TRANSMITTAL COVER SHEET

DATE: 21 June, 2024
TO: ALL PLAN HOLDERS OF RECORD
FROM: HUNTER SWATEK, AIA, PROJECT MANAGER
PROJECT: RAINBOW CITY RECREATION CENTER
GMC PROJECT NO. ABHM230021
RE: ADDENDUM NO. 3 AND
ACKNOWLEDGEMENT OF RECEIPT OF ADDENDUM NO. 3

ADDENDUM NUMBER 03

**PROJECT: RAINBOW CITY RECREATION CENTER
GM&C PROJECT NO. ABHM230021**

A9.01

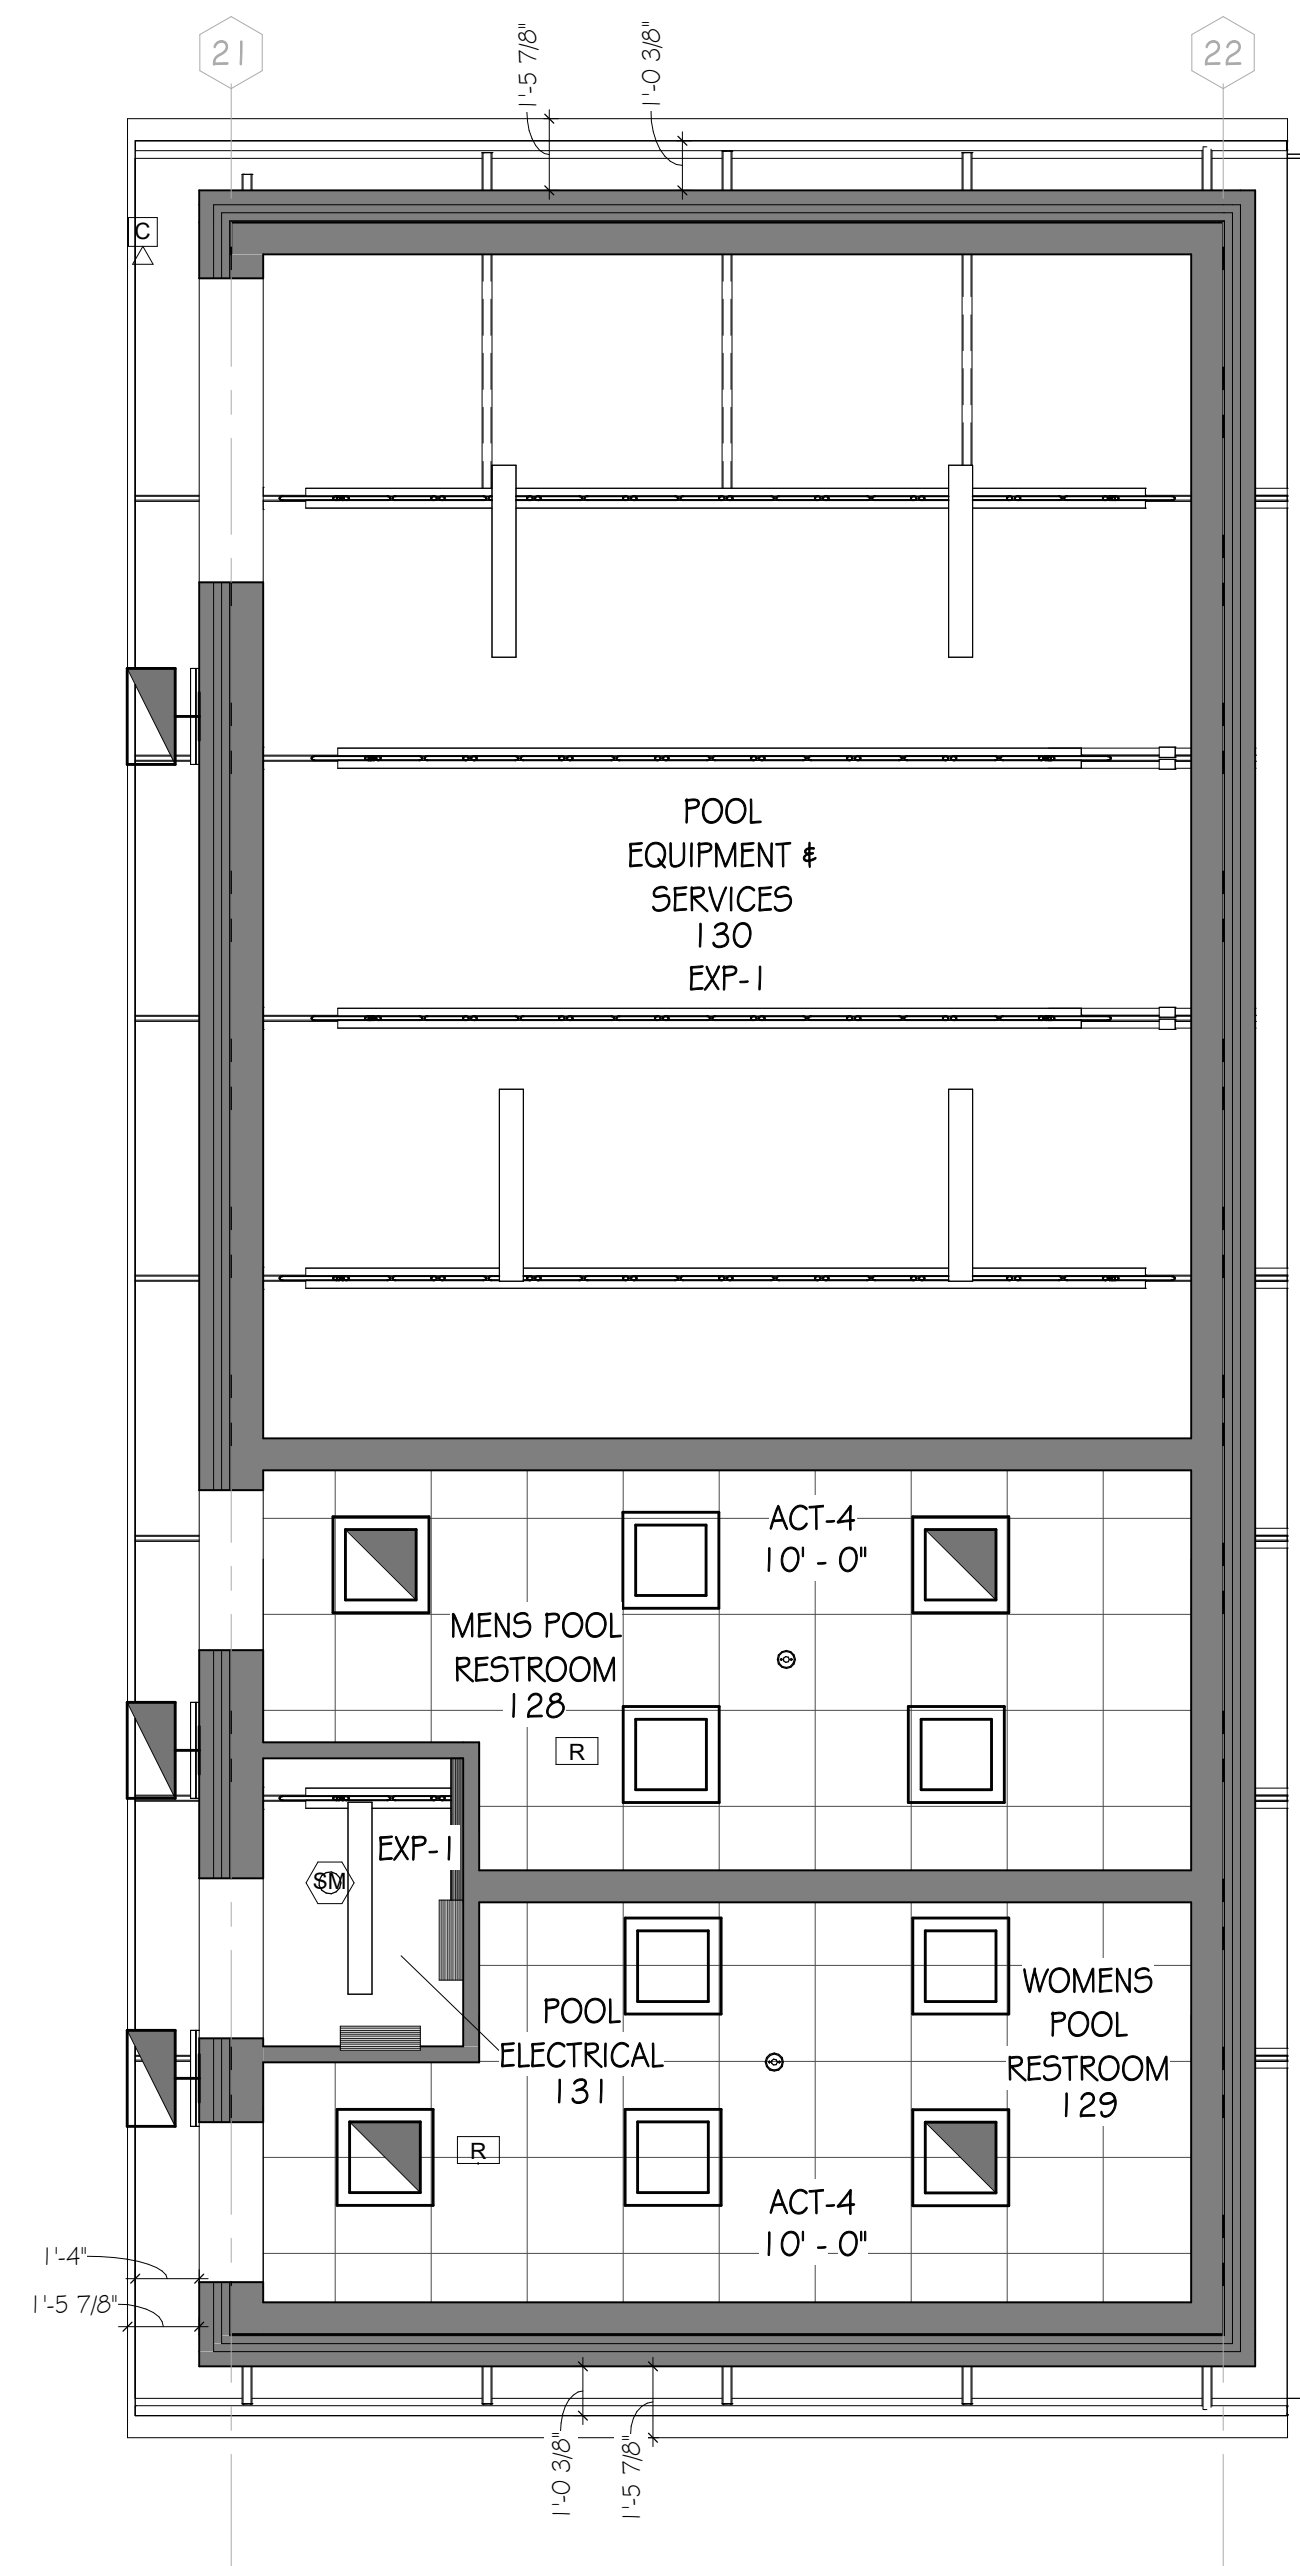
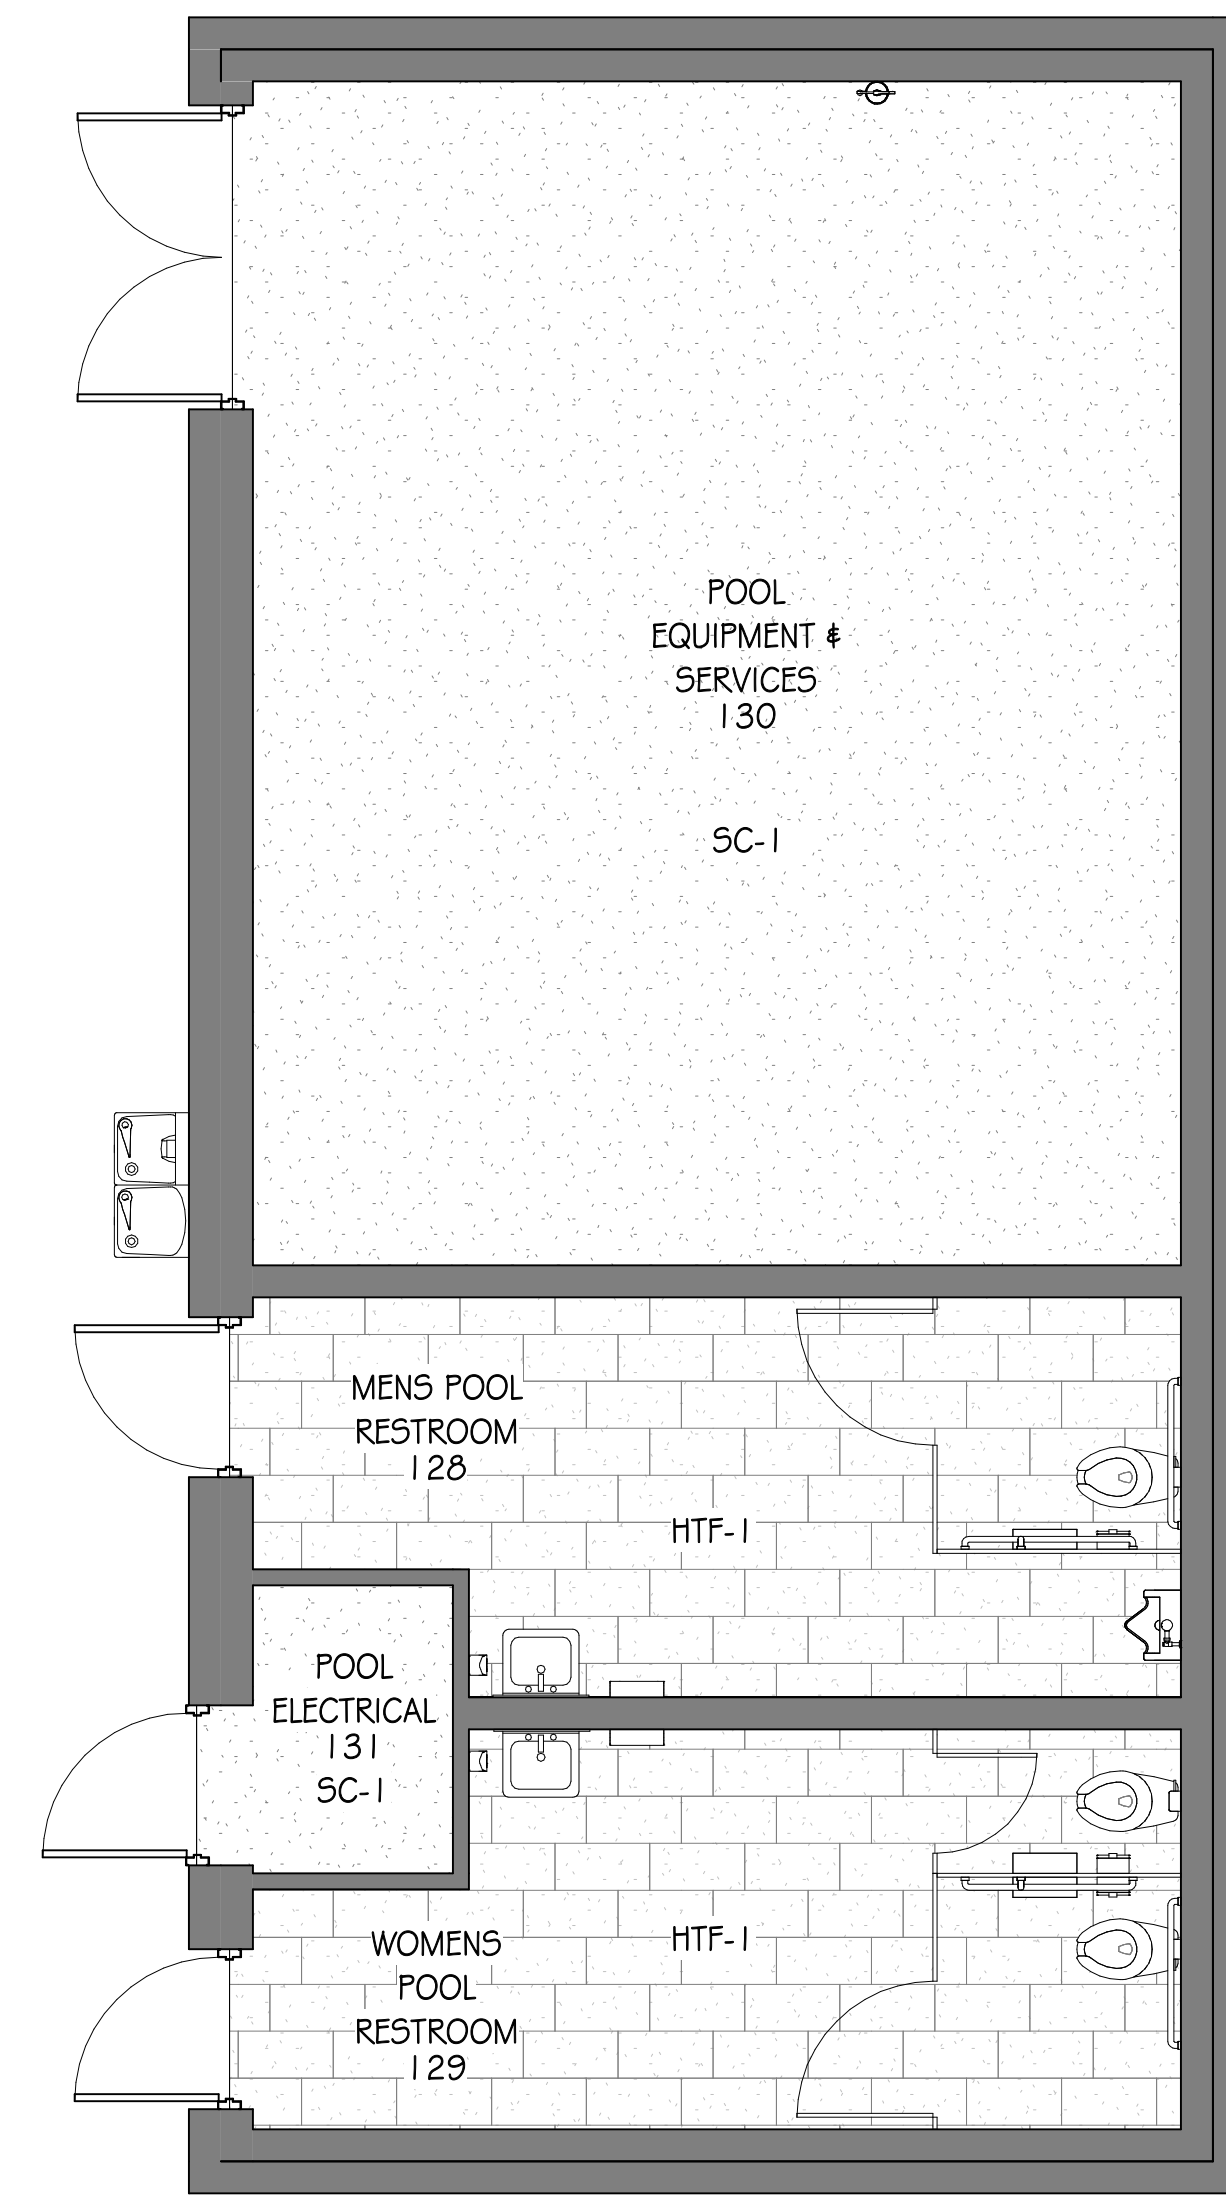
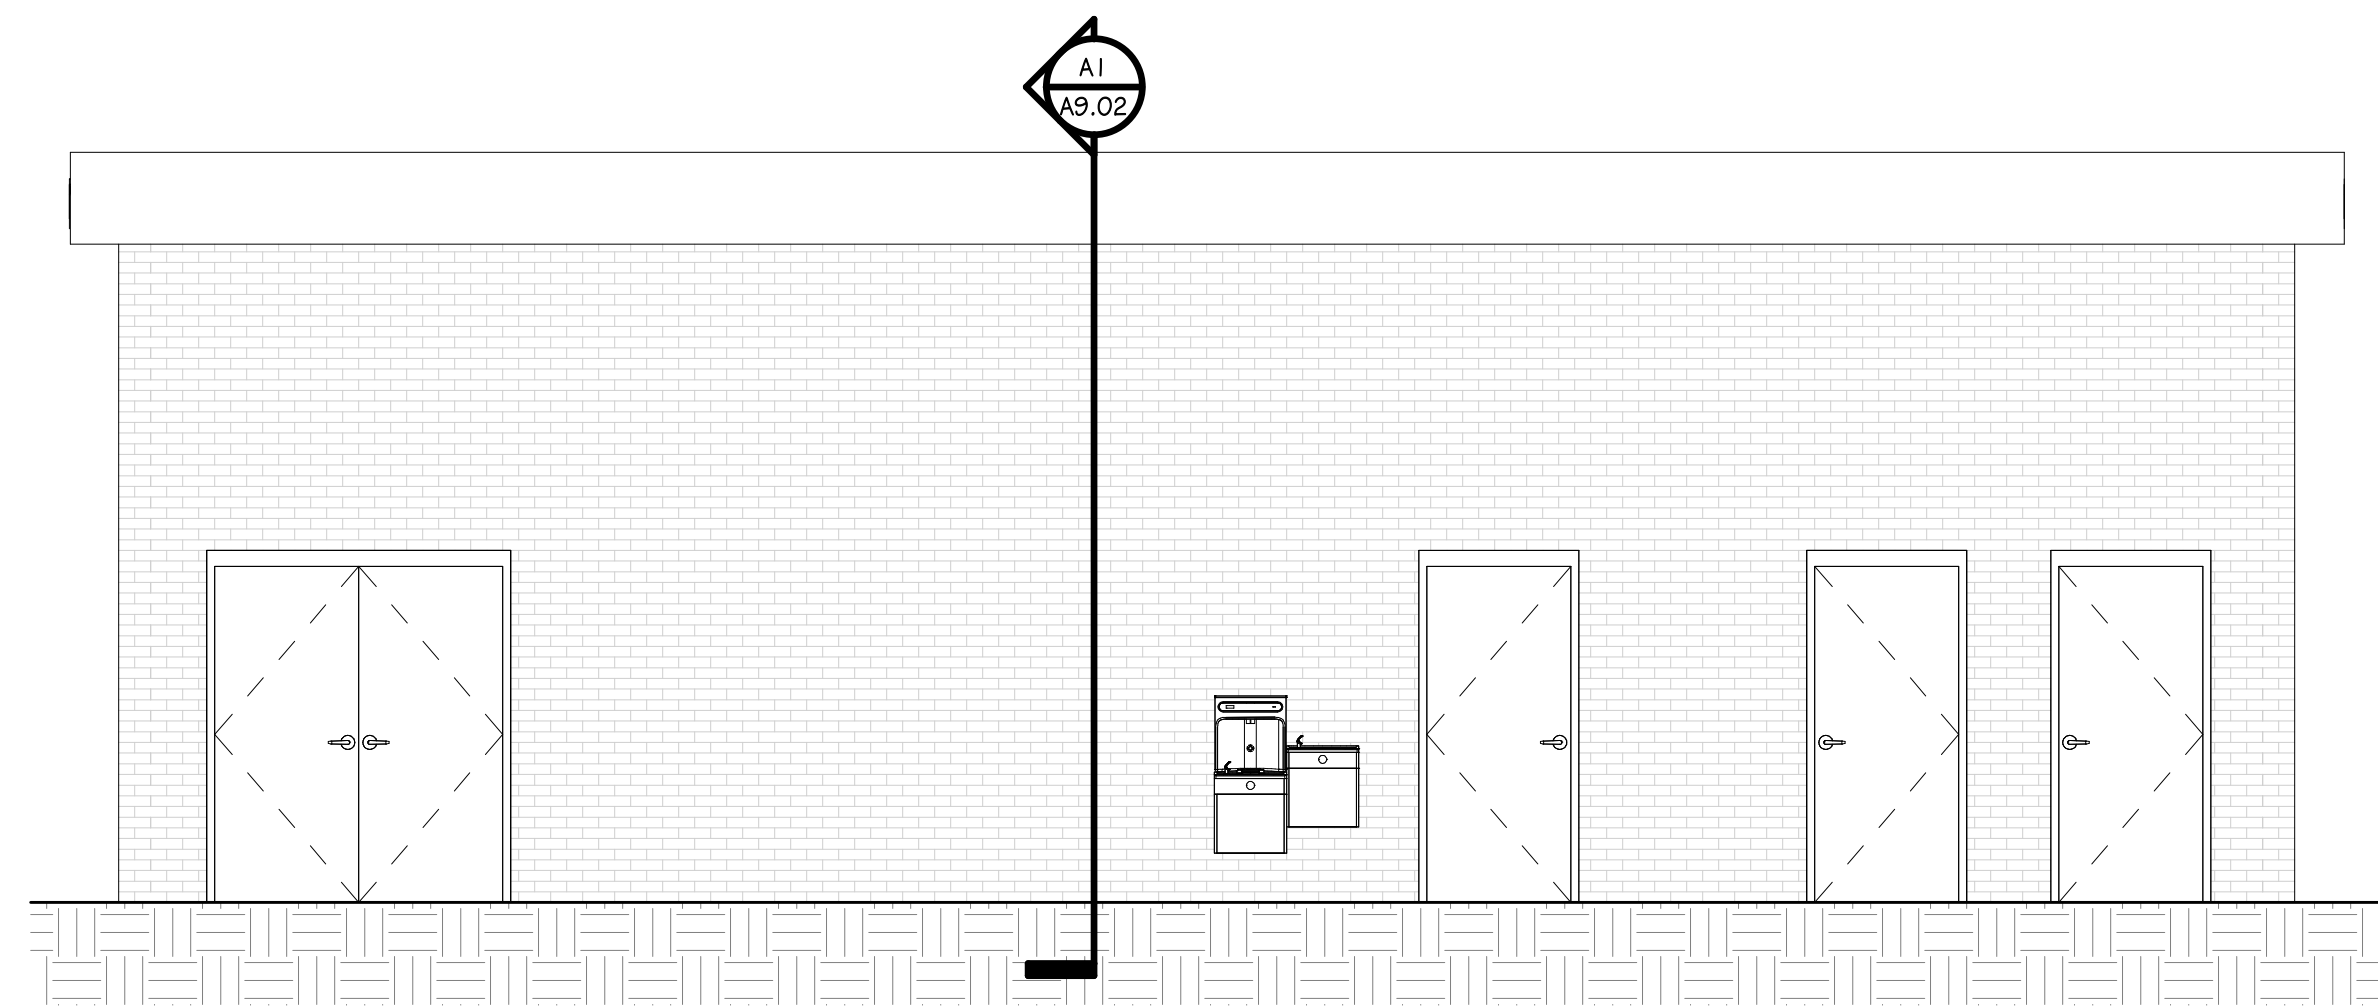
- A. **A2.01** – Reflected Ceiling Plan – Level 1
 - a. REVISED Concessions and Catering ceiling type
- B. **A9.01** - Pool Equipment Building
 - a. REVISED sheet drawings
 - b. ADJUSTED structural overhang depth in RCP
- C. **A9.02** - Pool Equipment Building Sections & Details
 - a. CREATED new sheet with roof details
- D. **A9.03** - Dumpster Enclosure
 - a. CREATED new sheet with plan, sections and details
- E. **A9.04** – Amphitheatre
 - a. REVISED sheet
- F. **C-101** – Site Layout Plan
 - a. ADDED Pool Collector Tank location
 - b. ADDED Wheel stops at parking adjacent to pool
 - c. REVISED Dumpster pad enclosure
- G. **C-102** – Alternate Site Layout Plan
 - a. REVISED Notes
 - b. REVISED Playground
- H. **C-201** – Grading Plan
 - a. REVISED grading around pool house and playground
- I. **C-202** – Alternate Grading Plan
